Interactive comment on “Development of glacial lakes and evaluation of related outburst hazard at Adygine glacier complex, Northern Tien Shan” by Kristyna Falatkova et al.

W. Haeberli (Referee)

Received and published: 30 April 2018

Fig. 1.

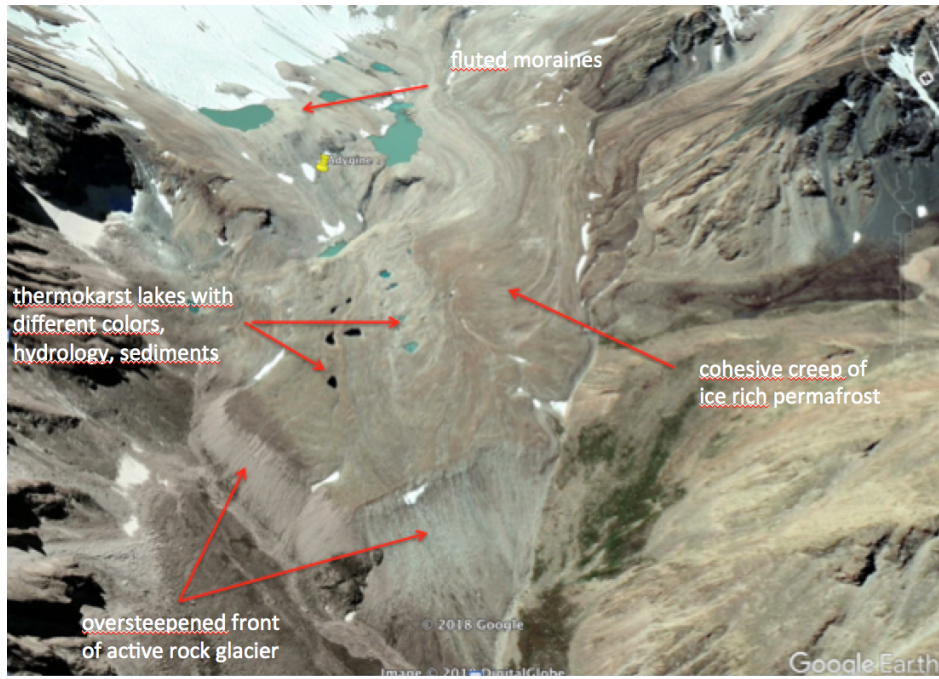
aspects (see also the uploaded annotated Google Earth image):

Geomorphology: Carefully reading the landscape helps with assessing the most important conditions and processes. The region under investigation is permafrost and rock-glacier country with numerous small to large landforms reflecting viscous creep of ice-rich frozen material. The corresponding modern scientific literature should be consulted and mentioned in order to understand the phenomena and the corresponding environmental conditions. Adygine glacier, for instance, had been (Little Ice Age?) in contact with an active rock glacier, the high, steep and bright fronts of which show clear signs of advance (freshly exposed talus material). The glacier forefield now exposed through recent glacier retreat is predominantly a sediment bed and contains fluted (striated) moraine. The latter is an important indication of temperate bed conditions underneath the glacier.
